AJHajh-20220125-ArunCrem Planning Response_LPA.docx

Y/184/21/DOC – CONDITIONS 8, 9 AND 10: DRAINAGE RESPONSE

Thank you for returning comments from your Drainage Engineer pertaining to planning conditions 8, 9 and 10 under planning permission Y/184/21/DOC for the Crematorium, Bognor.

Project No.	Originator	Volume	Lvl/Loc	Type	Role	Number	Rev
13591	CRH	XX	XX	DR	C	5310	P1

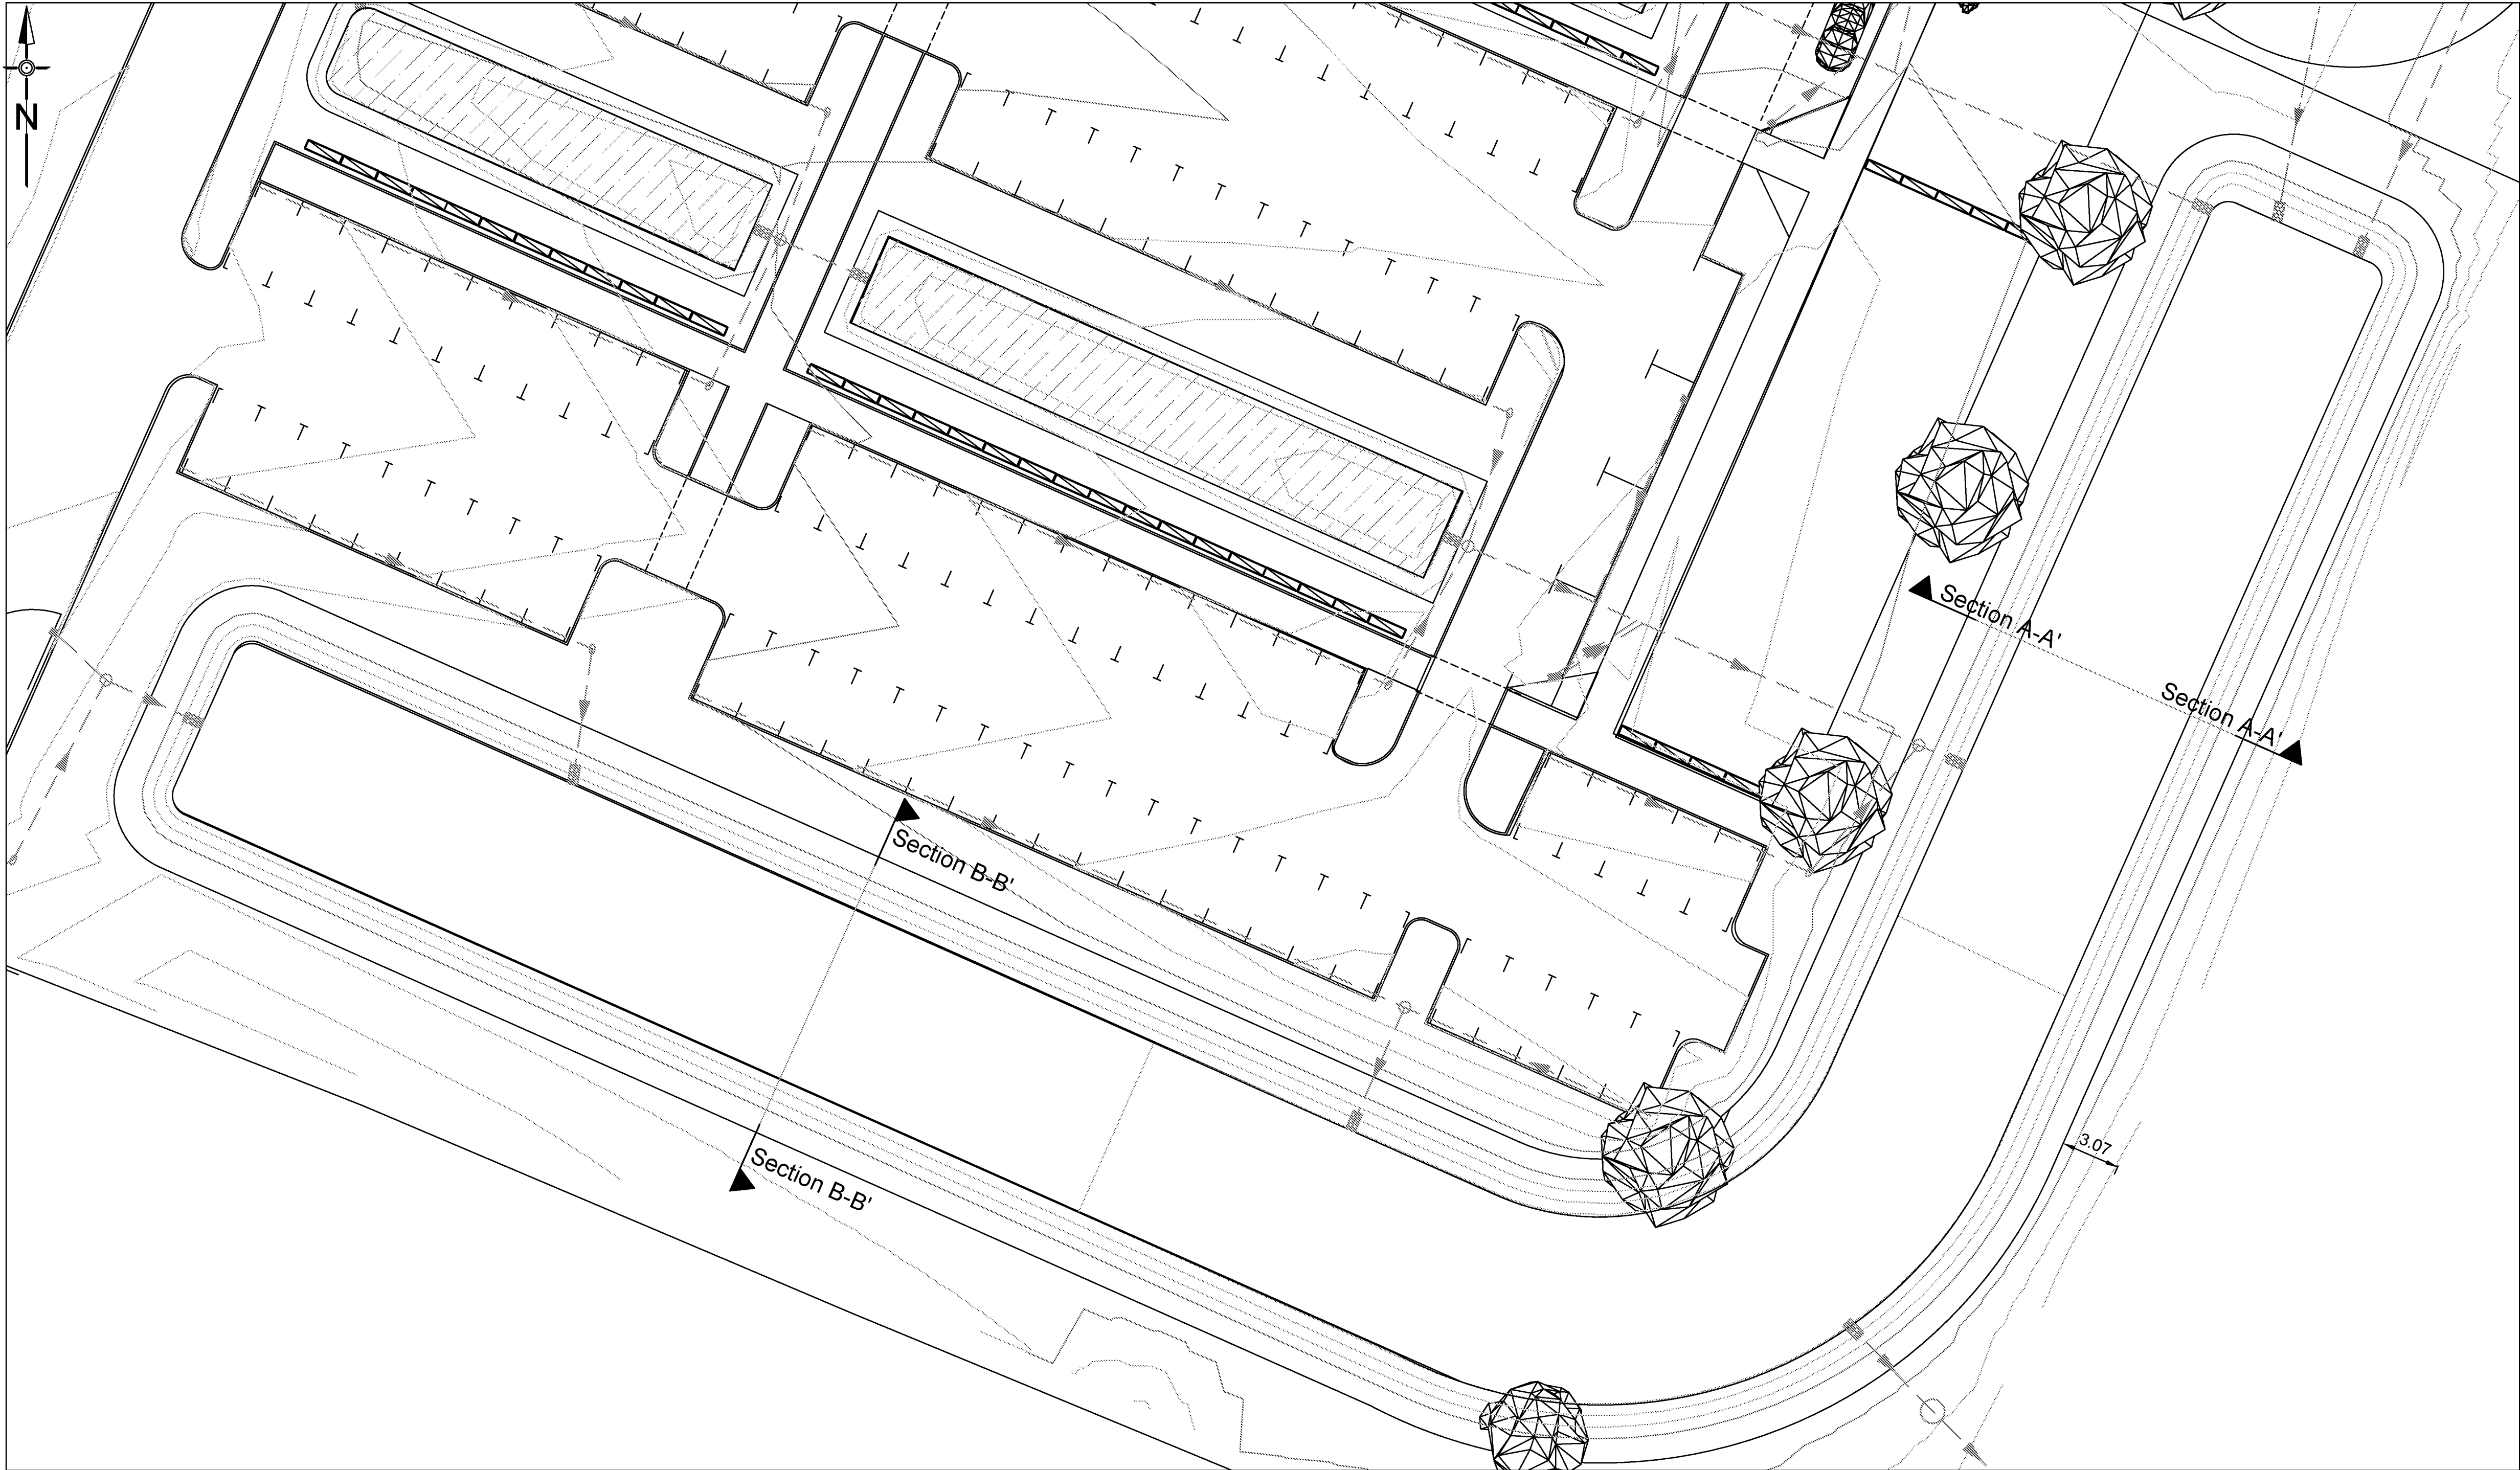
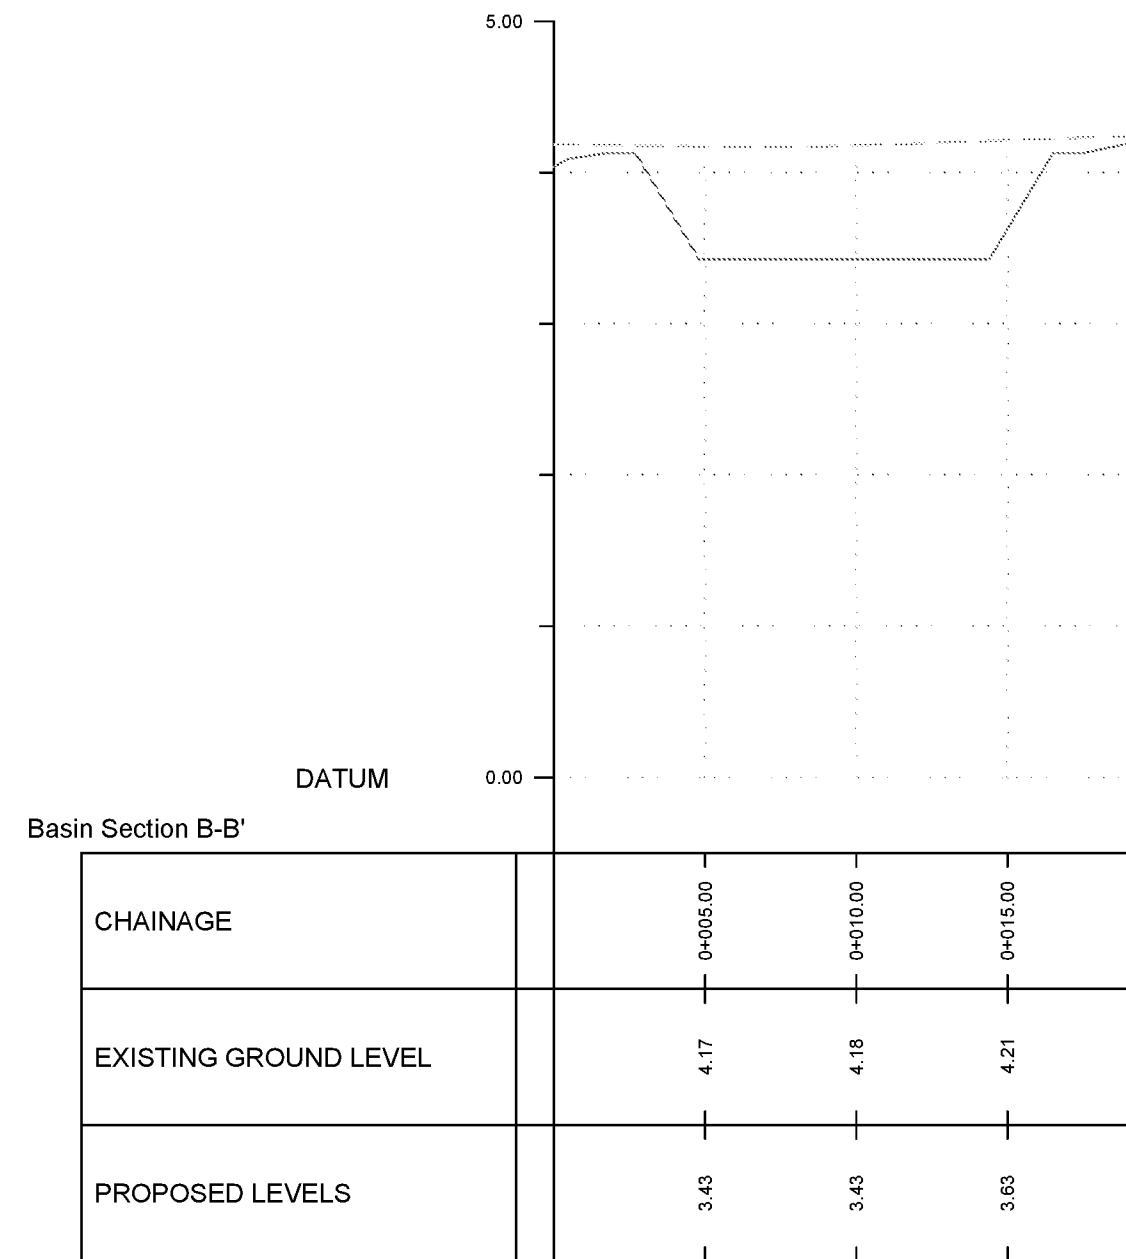
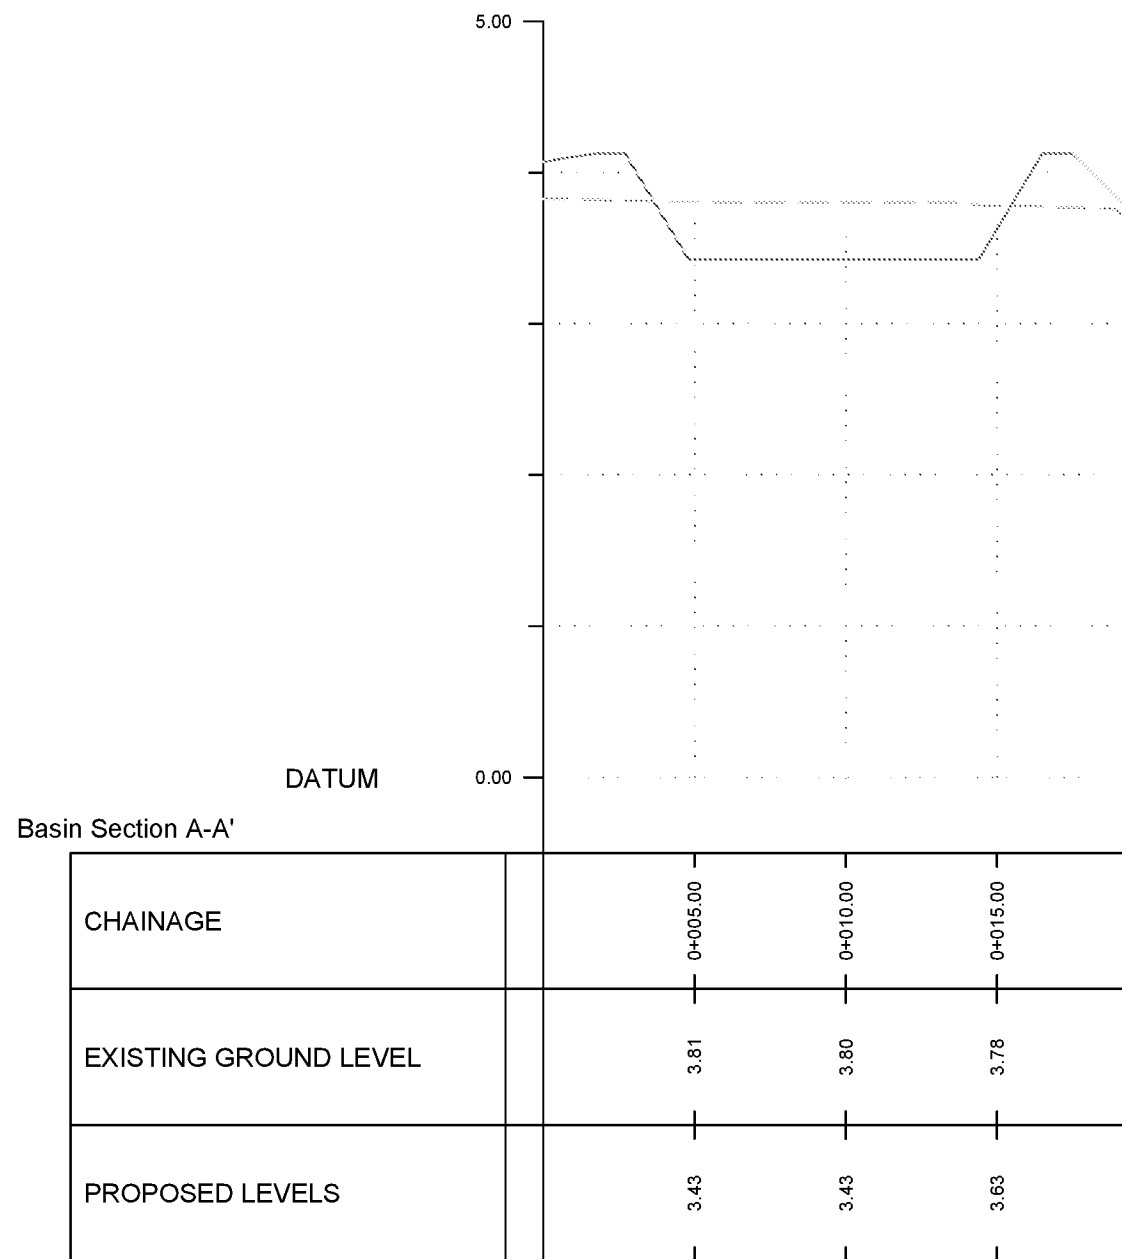
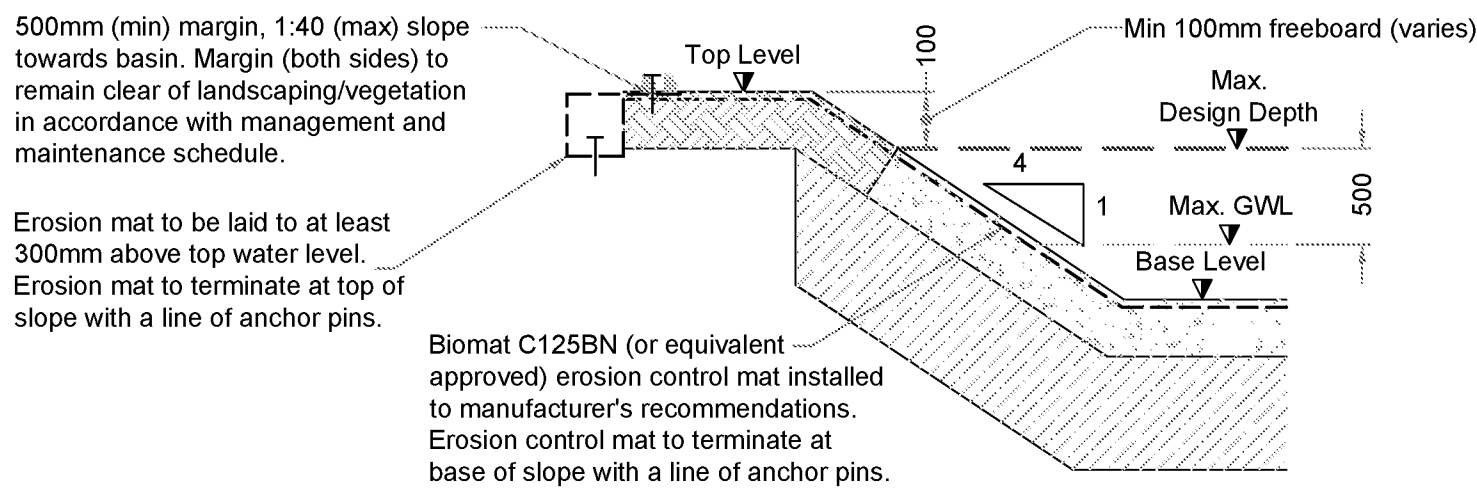
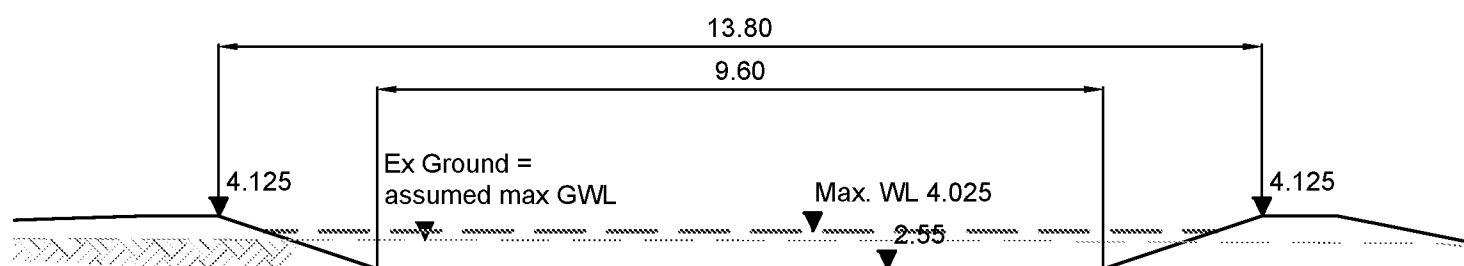
9. Please supply site specific construction details of the attenuation basin, showing invert level, top of bank level, width at bed and width at bank.

9. Please see enclosed basin detail drawing *13591-CRH-XX-XX-DR-C-5310 Revision P1*.
